Oregon State University
Construction Contract Administration
MERRYFIELD HALL RENOVATION

ADDENDUM NO. 5

Subject: OSU Merryfield Hall Renovation Project

DWG. NO.
S1.0
 2 of 16
 160553-B

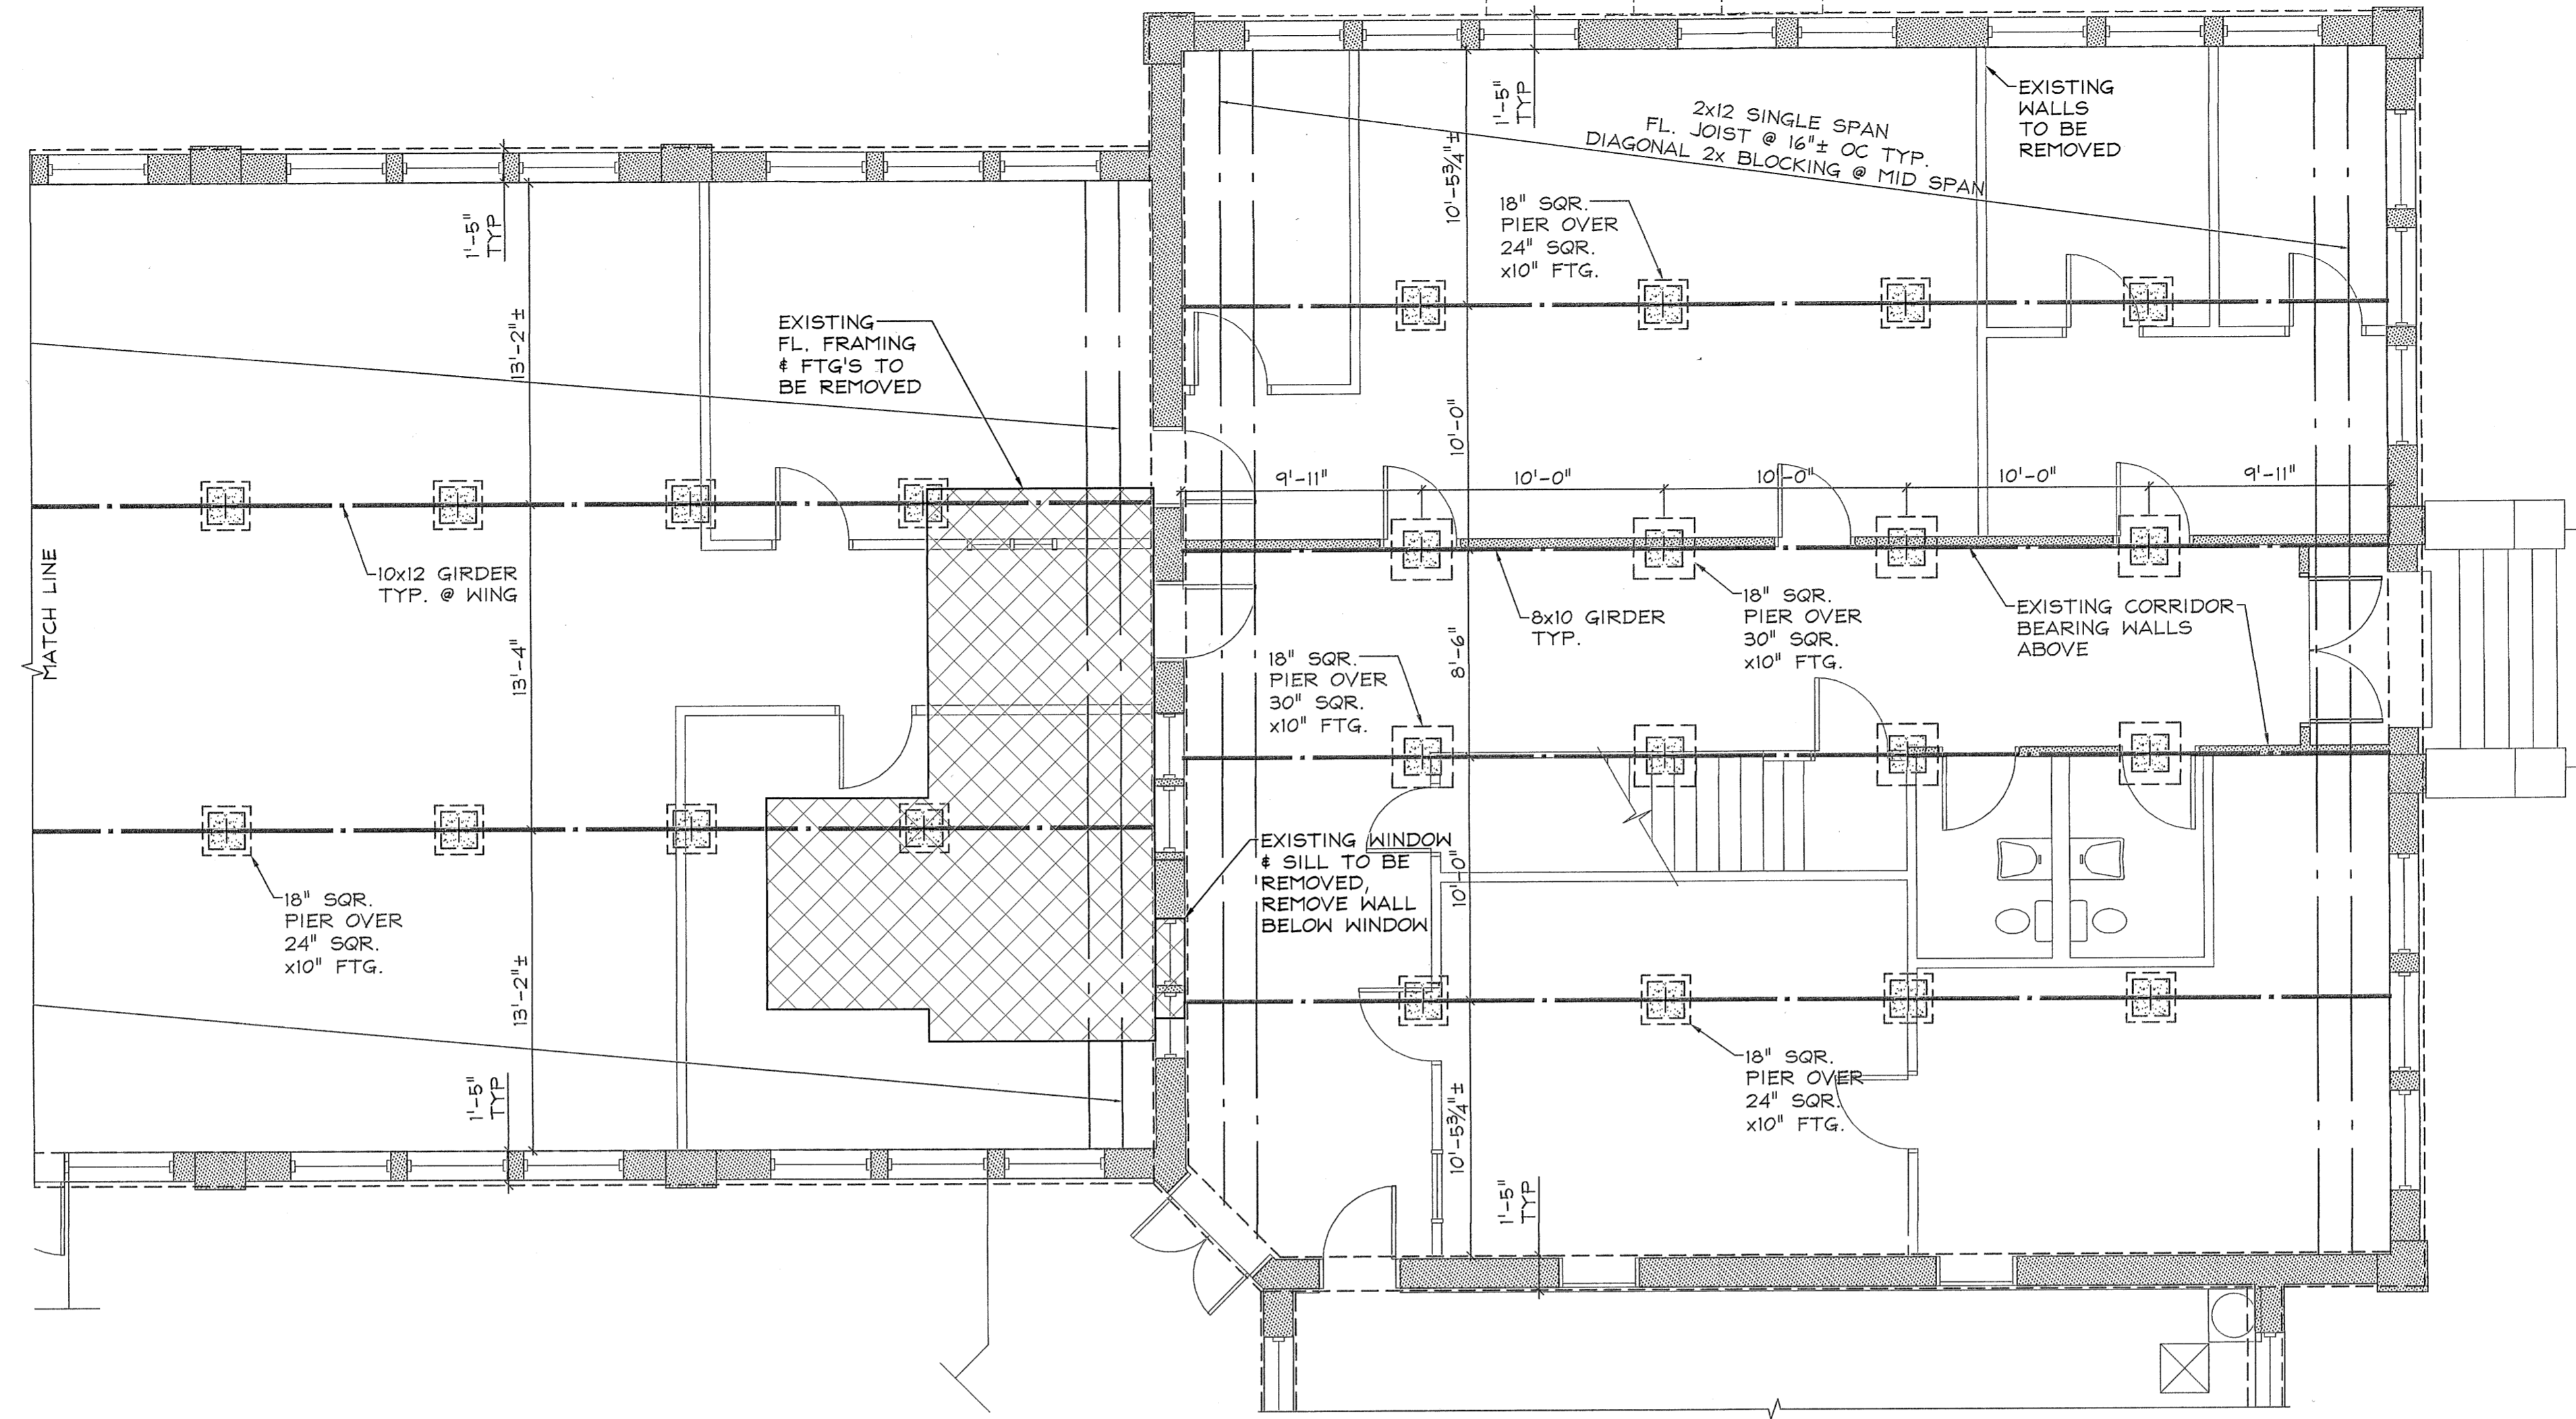
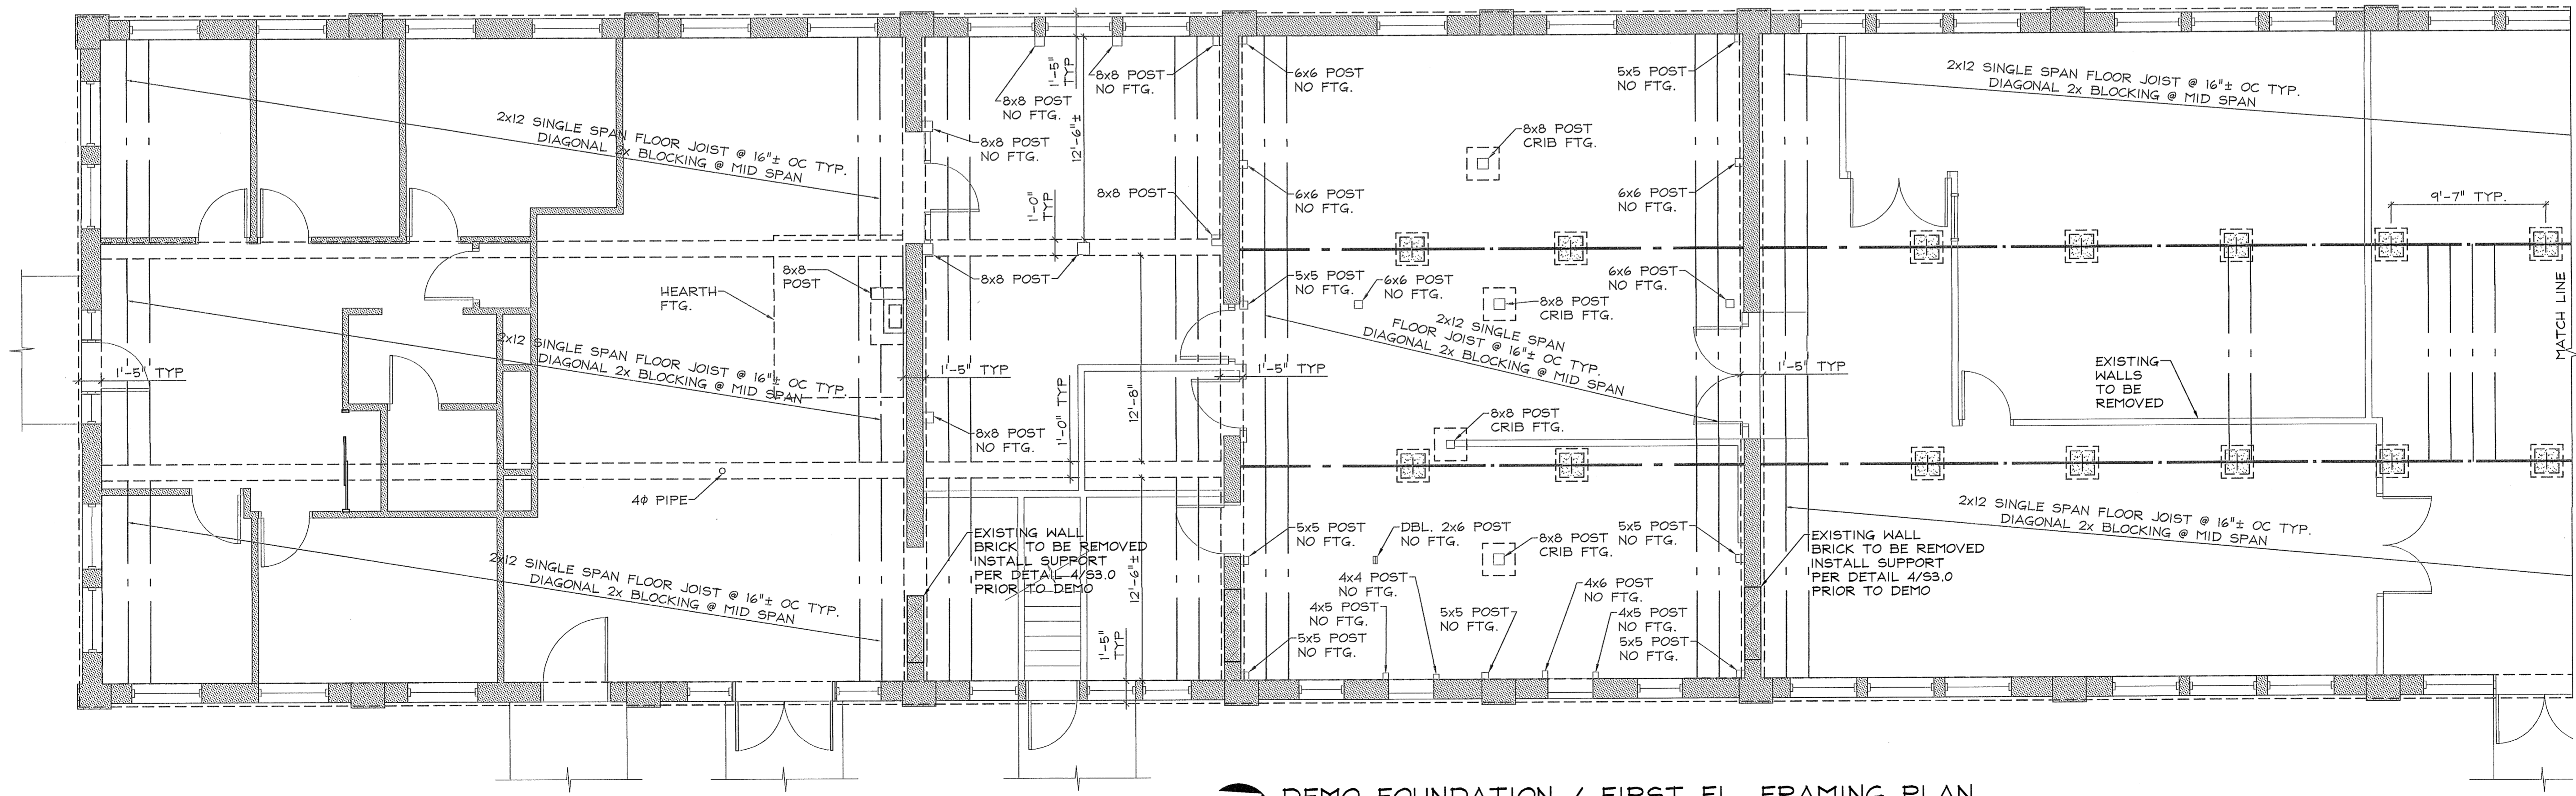
- 1) Sheet S1.0 First Floor Framing/Demolition Plan - Clarification: The existing joists have been shown with a lighter line weight. This light line weight did not come across clearly on the scanned copies included with the bid documents. The project scope does not require all of the floor joists to be replaced. The drawing Has been replotted to improve drawing clarity and attached to this addendum.
